**Traffic Safety and Signage Committee
Meeting Agenda
April 6, 2026
2:00 PM
Bentonville City Hall**

1. NW 5th & Bella Vista Rd- Sidewalk & Roundabout Informational

Subject: NW 5th & Bella Vista Rd- Sidewalk & Roundabout
Elizabeth Fuller, lizabeth0905@gmail.com

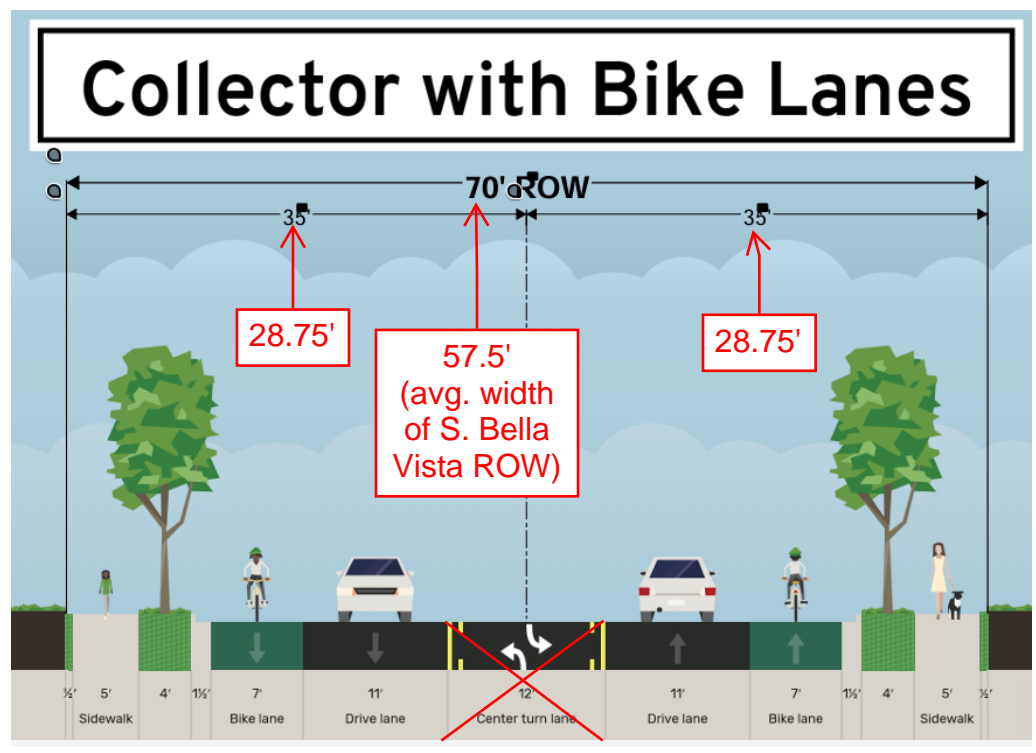
ADD MUTCD R1-5C TO CROSSING SIGNS. ADD STOP BAR 20' EACH DIRECTION FROM CROSSING

ADD MUTCD R1-5C TO CROSSING SIGNS. ADD STOP BAR 20' EACH DIRECTION FROM CROSSING

ADD MUTCD R1-5C TO CROSSING SIGNS. ADD STOP BAR 20' EACH DIRECTION FROM CROSSING

RRFB W/ STOP BAR 20' EACH DIRECTION FROM CROSSING

ADD MUTCD R1-5C TO CROSSING SIGNS. ADD STOP BAR 20' EACH DIRECTION FROM CROSSING

ADD ROUNDABOUT FOR TRAFFIC SLOWING AND EGRESS INGRESS CONTROL AT INTERSECTION (FUTURE PROJECT)

ADD SIDEWALK ON WEST SIDE OF BELLA VISTA NOW WITH IDIQ CONTRACTOR FUNDS. THIS IS A VERY DANGEROUS CROSSING AND IMPERATIVE FOR SAFE ROUTES TO SCHOOL
